**Summary Of The Office Action & Formalities**

U.S. APPLICATION NO. 09/242,822  
AMENDMENT UNDER 37 C.F.R. § 1.111

Fig. 1

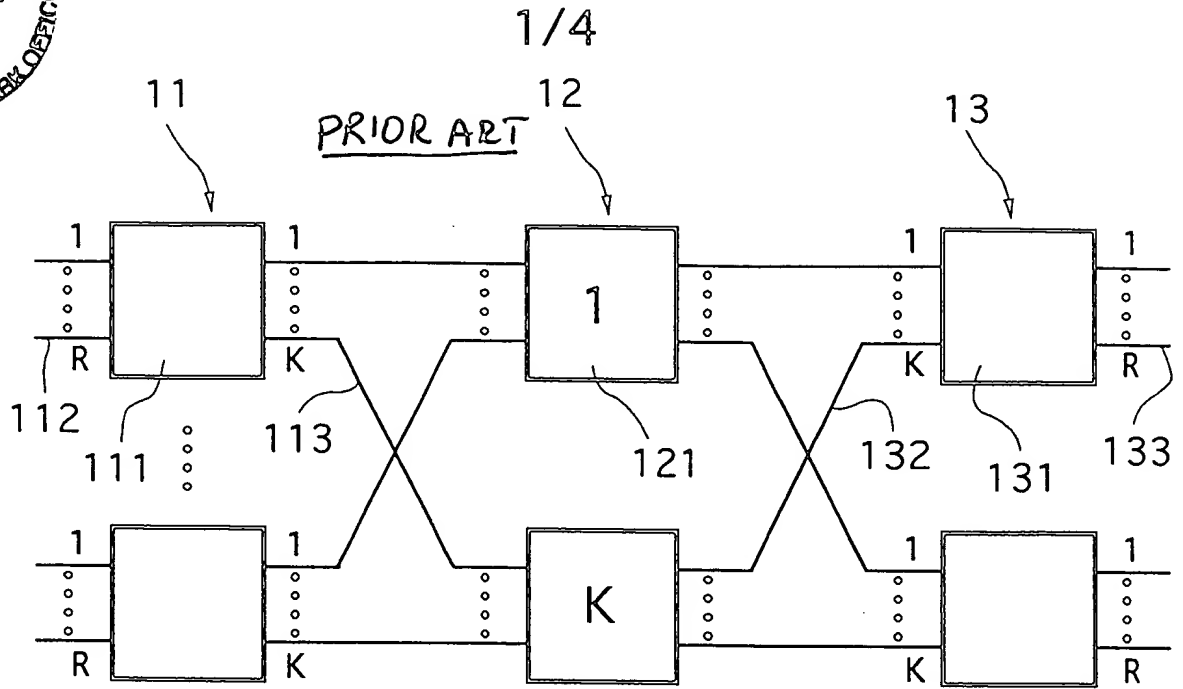
The drawings are objected to for the reasons set forth at page 2 of the Office Action. Applicant is submitting herewith proposed drawing changes to Figs. 1 and 4A, labeling these figures as "Prior Art." Applicant is also amending the Specification to clarify the description of Figs. 4A and 4B.

With respect to Fig. 4B, Applicant disagrees that this figure discloses only that which was in the prior art. To the contrary, Fig. 4B is not prior art, since the switching architecture is different from the Clos network illustrated in Fig. 1. In particular, Fig. 4B is a specific example

Fig. 4B

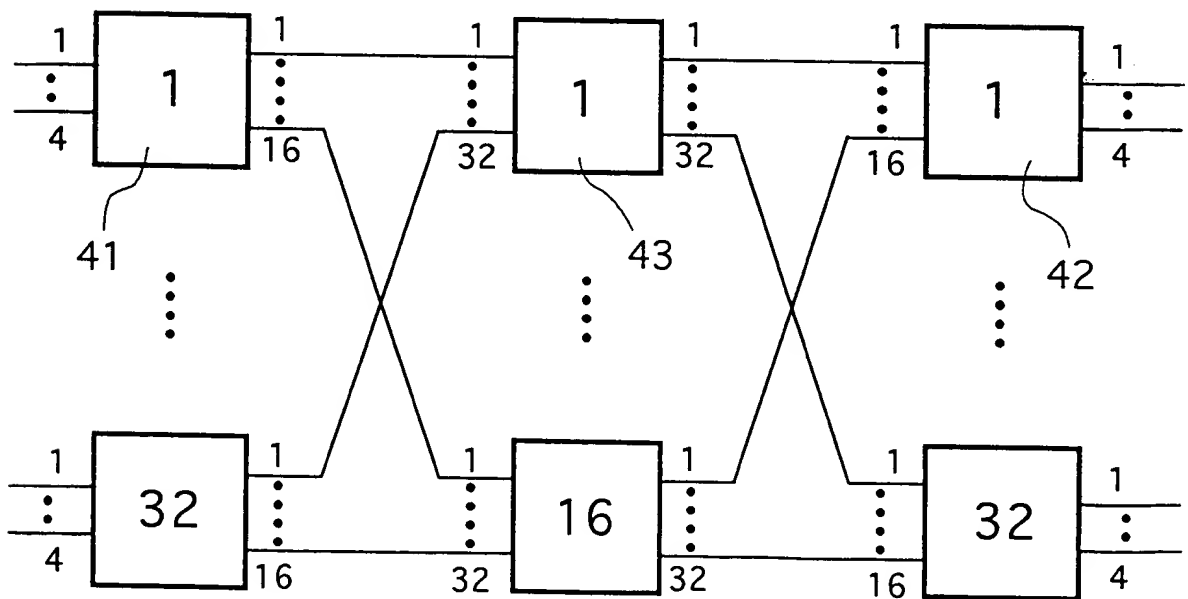
of the network of Fig. 3 and, therefore, must be viewed in the context of Fig. 3. Indeed, the number of inputs and outputs for each matrix and the associated exclusive relationship between the inputs and outputs of each first and last stage matrix as explained at page 9 of the specification are specific examples of the generalized network of Fig. 3 and are different from that of a Clos network. These differences, alone, are sufficient to prevent the figures from being characterized as disclosing prior art.

Figures 4A and 4B show an advantageous structure based on the network from Figure 3 [allowing broadband transfers (Figure 4B) and narrowband transfers (Figure 4A); and], with Fig. 4A showing a known device allowing narrowband transfers, and Figure 4B showing a device according to the invention and which allows wide band transfers, this latter device being able to be derived from incomplete prior art matrices and by restricting routing in these derived prior art matrices to allow broadband transfers (Figure 4B) and narrowband transfers (Figure 4A); and
